DOCUMENT: Unit 2 Offsite Dose Calculation Manual

TITLE: Revision 8 to the Offsite Dose Calculation Manual

Revision 8 to the Unit 2 ODCM was completed to comply with a milk location change in the environmental program. In addition, a typographical error was corrected in Part I, liquid dose factors were corrected in Part II for typographical and/or data input errors identified from an independent verification, and a source document for an environmental parameter was corrected.

FIGURE 5.1-2

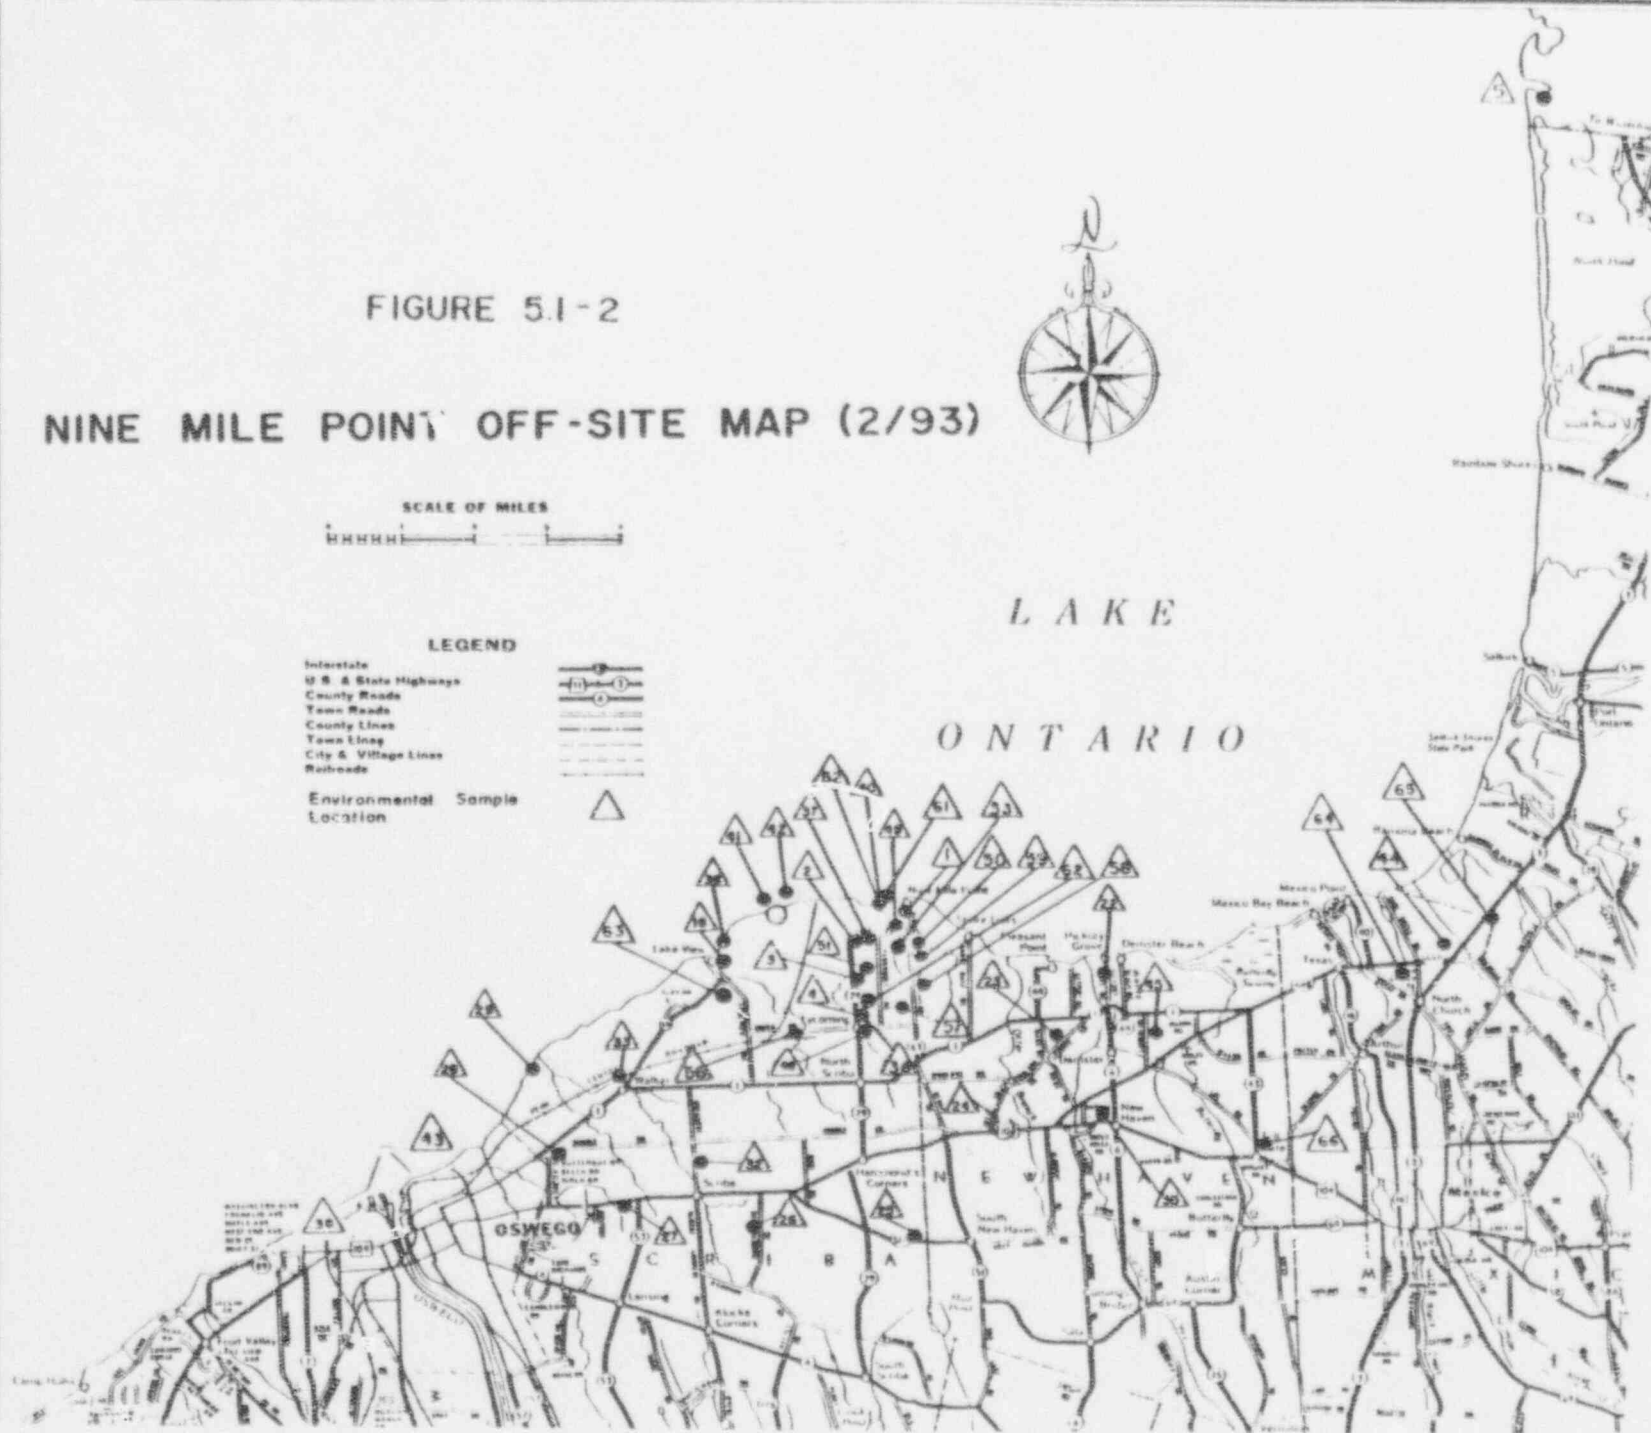
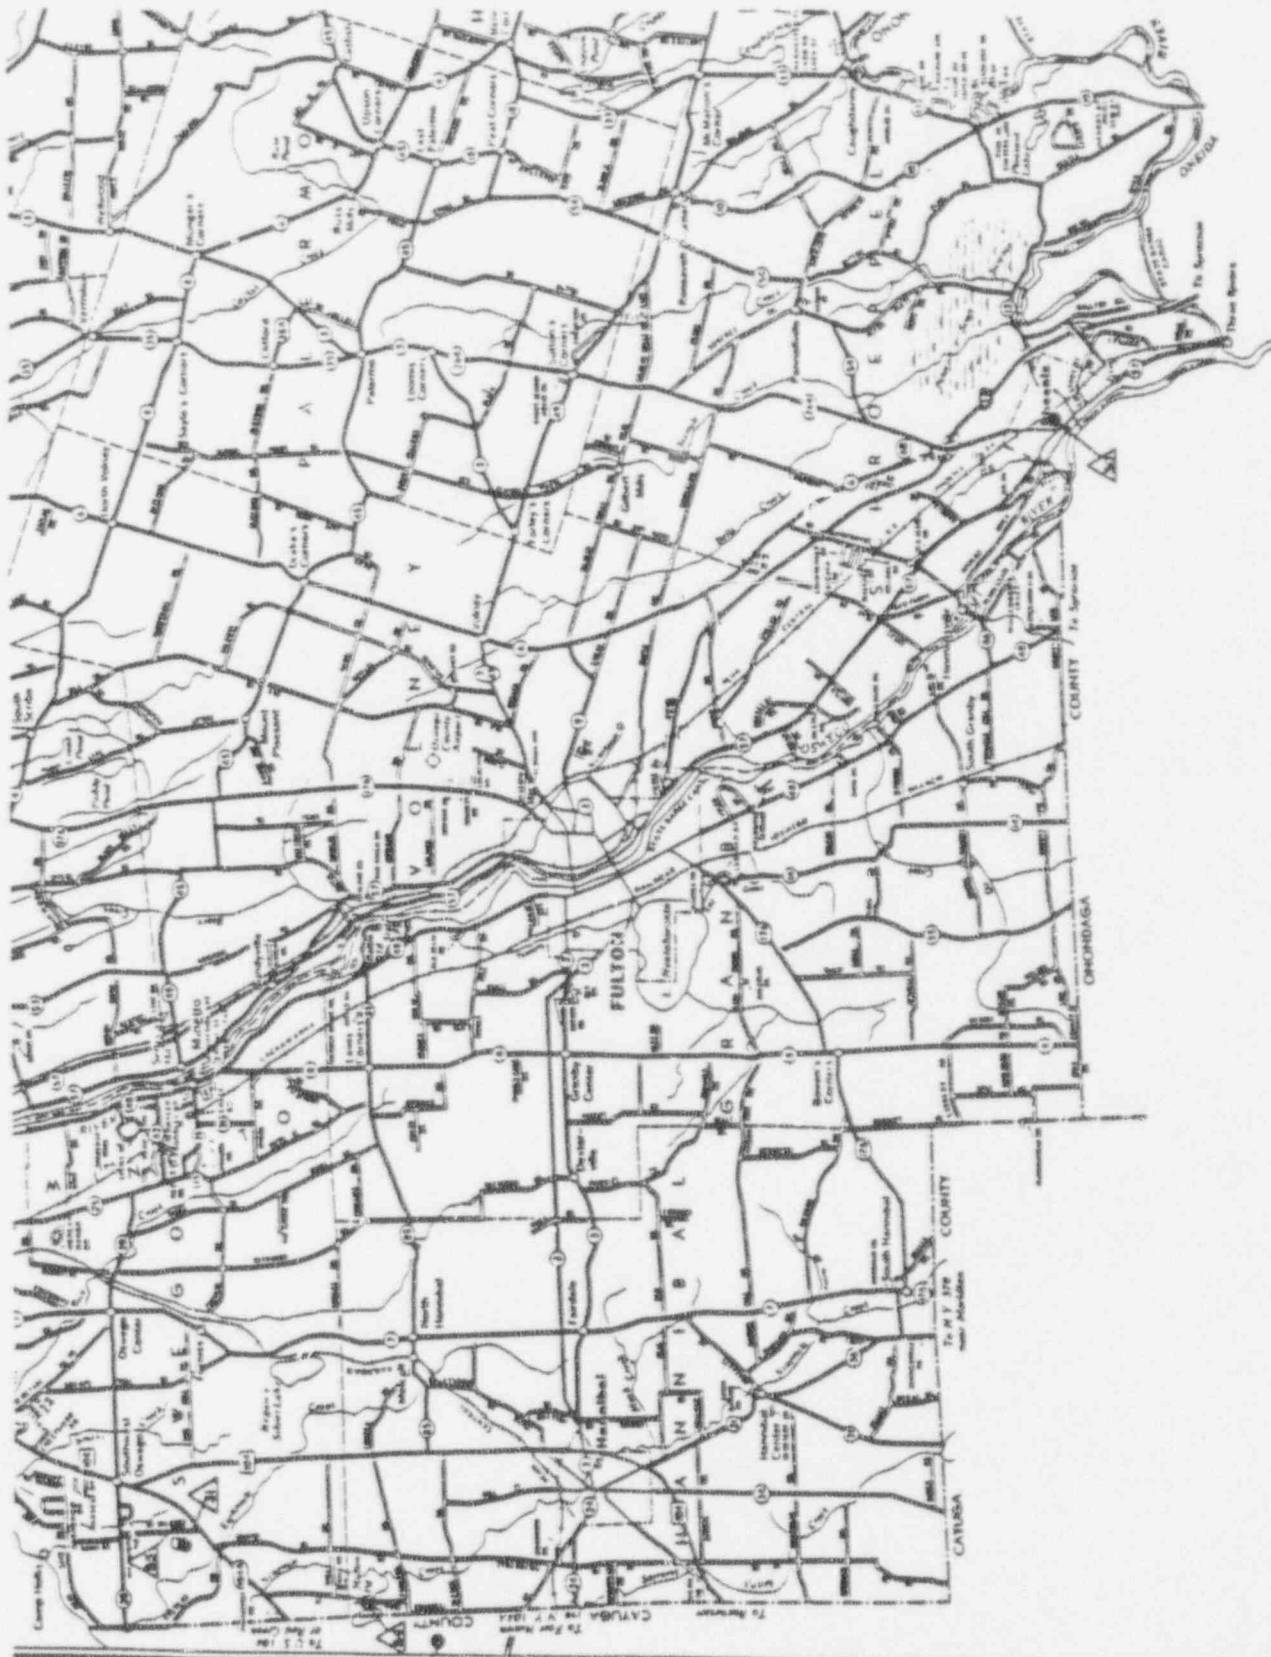
- (2) Part II - pp. 28, 29, & 31 - Tables 2-2, 2-3, & 2-5 - The Np-239, Sr-92, I-133, Ba-140, Tc-99m and W-187 values contained various typographical and/or data input errors as identified from an independent verification. As these nuclides were not identified and quantified during the period from the last ODCM revision, there is no impact on the compliance calculations for liquid effluents.
- (3) Part II - p. 55 - A correction to the source document for the shoreline usage factor on Table 3-24 was completed.
- (4) Part II - pp. 58, 104a,c - The milk location number 46 was deleted. The farmer sold his herd of cows. In addition, pp. 104a and 104c were deleted as no sample locations were on those map sections of Figure 5.1-2. The pages were re-numbered.
